**15th ST EAST @ 51st AVE EAST  
AND PINE ST RELOCATION  
QUANTITY SHEET  
ADDENDUM I**

**ADDENDUM I**

**15th ST EAST @ 51st AVE EAST  
AND PINE ST RELOCATION  
GENERAL DETAIL  
ADDENDUM I**

C. MOWBRAY P.E.  
FLORIDA P.E. # 46777  
*Christopher Lee Mowbray*  
7/9/13  
Signature & Date  
**SHEET 12**

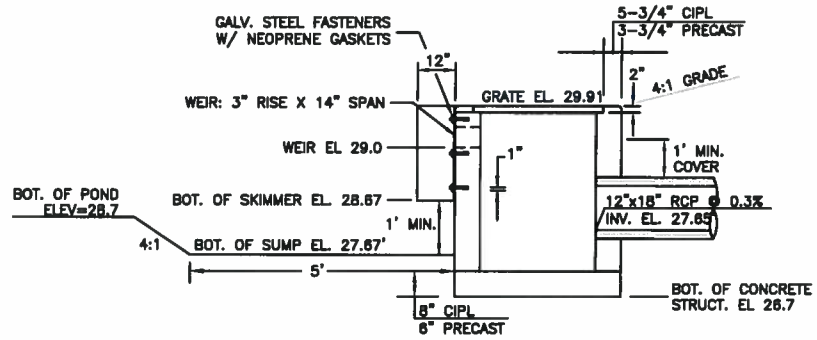
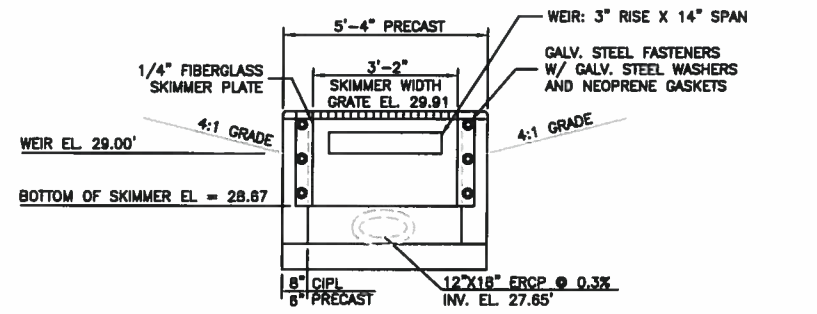
1)LINE ITEM NUMBER 46 TYPE AB CURB & GUTTER HAS BEEN REMOVED FROM THE QUANTITY SHEET.

2)LINE ITEM NUMBERS FROM 12 TO 85 HAVE BEEN CHANGED.

5'-6" x 4'-0" CONC. BLOCK BOX PER MANATEE CO. 202.1/202.4  
**PROPOSED CONTROL STRUCTURE & SUMP  
DETAIL FOR DRY POND-PINE STREET**  
N.T.S.

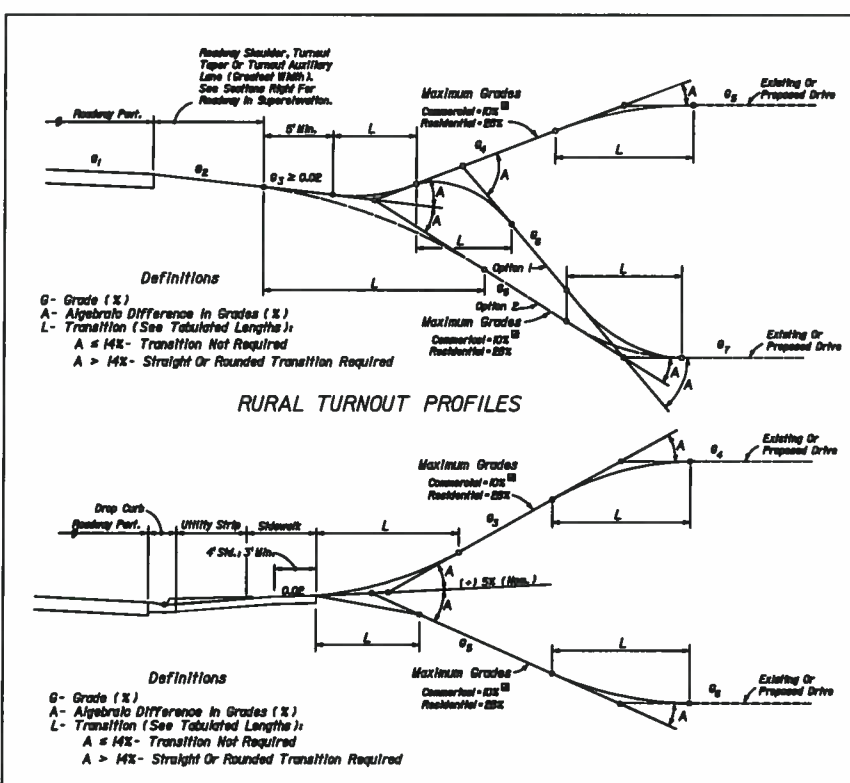
△ PROPOSED TRACK ROADWAY CROSSING DETAIL AT EXISTING R.R.-51th AVE. E.  
AND PROPOSED 4' SIDEWALK AT EXISTING R.R. CROSSING GATE @ 51th AVE. E.  
DETAILS HAVE BEEN REMOVED FROM THE PLANS.
